# Planning Officer's Report - LDCA 12th September 2024

**APPLICATION 2024/23** – Proposed three bedroom, split level dwelling.

PARCEL NGO486

#### **Diagram 4: Site Section**

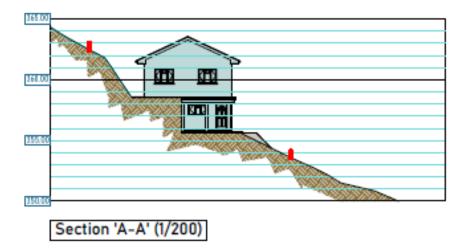
Embankment on the lower level at the rear of the car parking spaces as a result of the proposed site excavation may require retaining due to its vertical cut. This includes the placement of gabions (details will be determined under the Building Regulations).
